"AS BUILT PLANS"

PLANS FOR PROPOSED *Contractor ~ E.A. Smith Construction Co
& The Bachner Co. (JV)*
HIGHWAY BRIDGE PROJECT *Project Engineer ~ William L. Gute*
NO. F-095-5(4) *Time Began ~ April 25, 1962*
MUNCASTER CREEK BRIDGE *Time Ended ~ Aug. 12, 1963*
& NO. SP-3014
LITTLE BOULDER CREEK BRIDGE
HAINES CUT-OFF
FAP ROUTE 95
ALASKA

MUNCASTER CREEK
ROUTE NO. F-95
ABUTMENT NO. 2

PLAN
Scale: 1/8" = 1'-0"

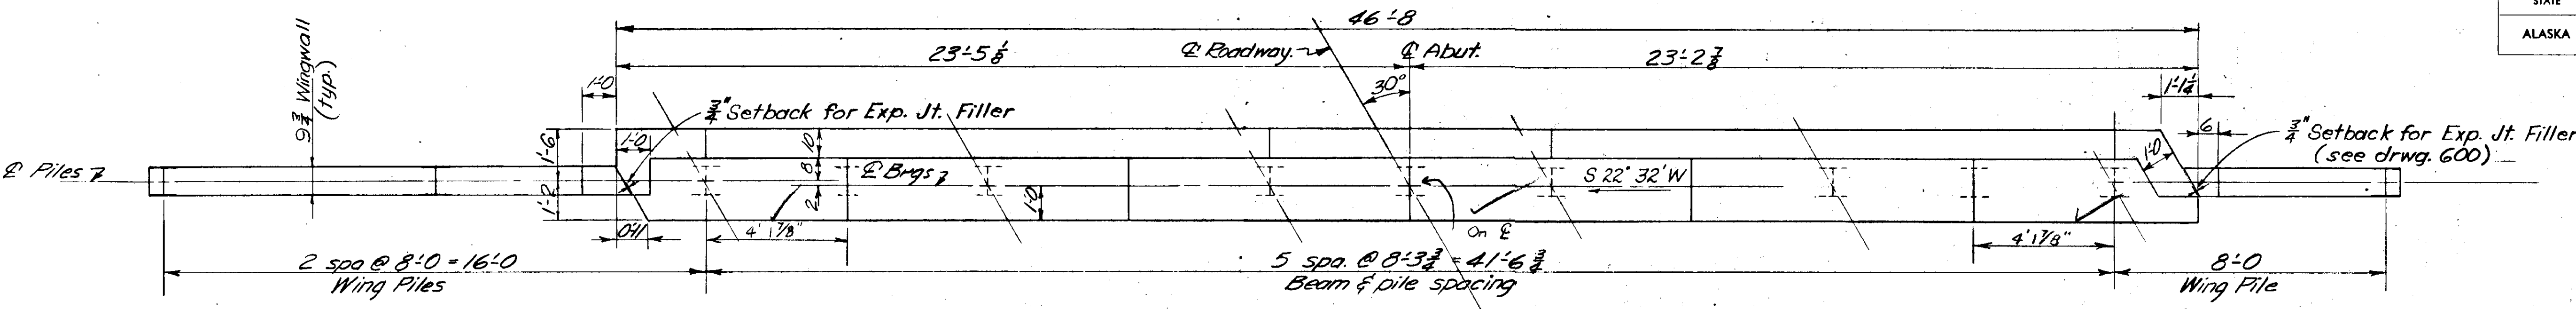
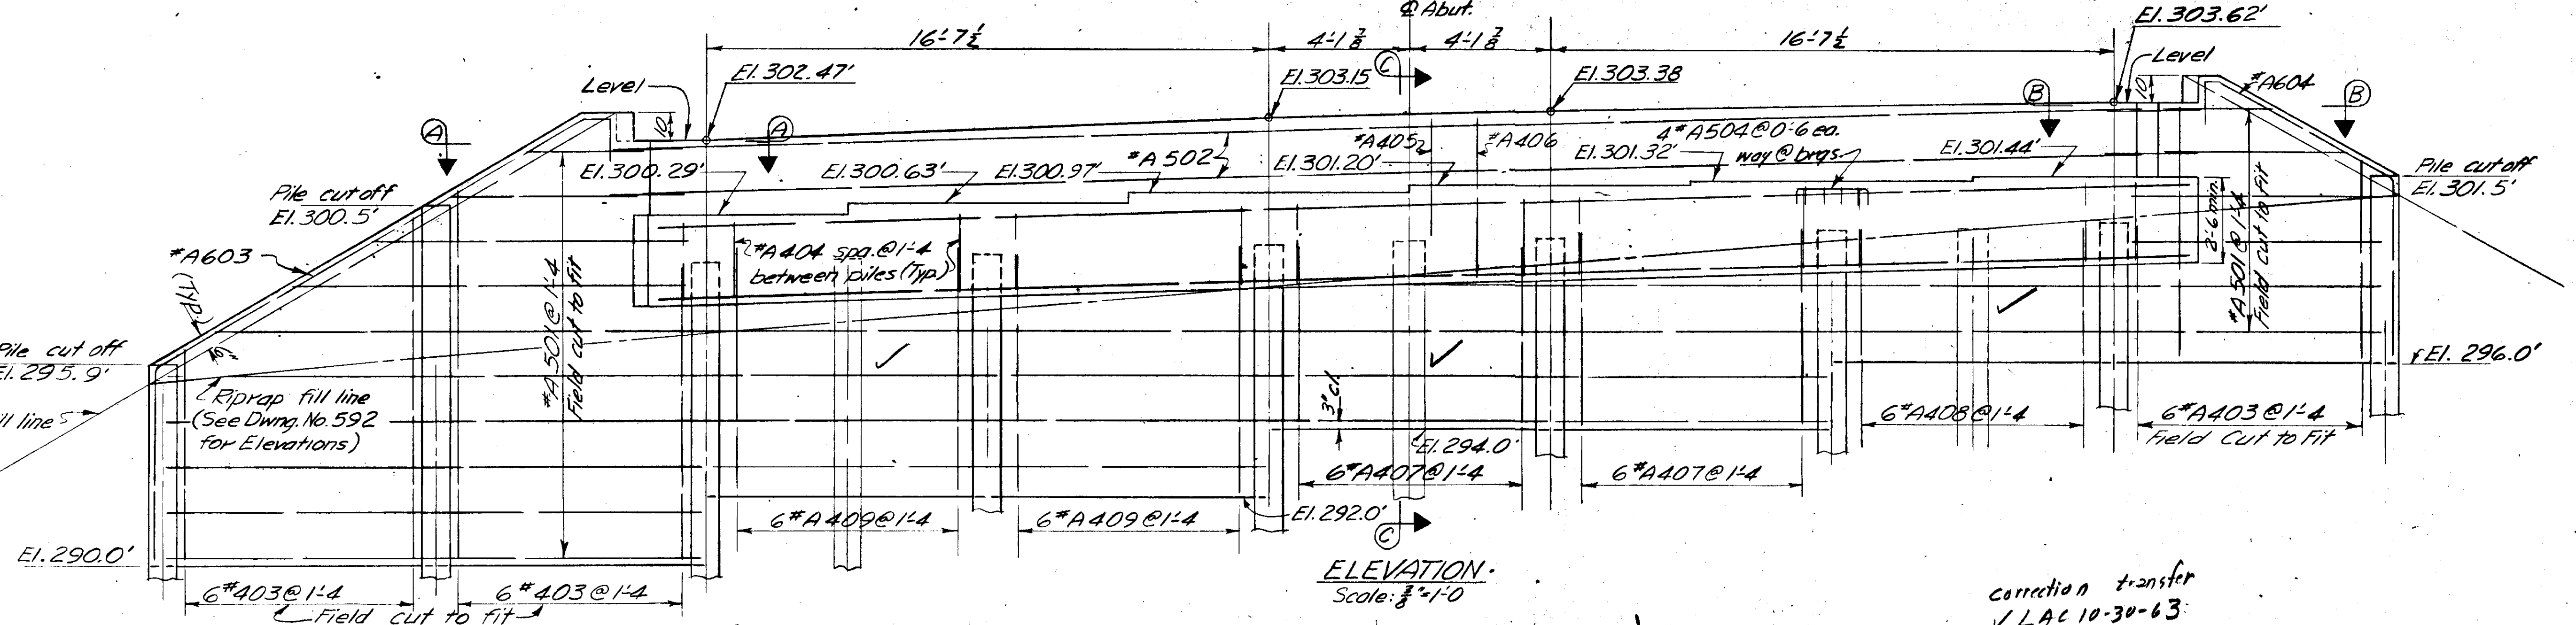
Note: Three additional piles as per change order #2
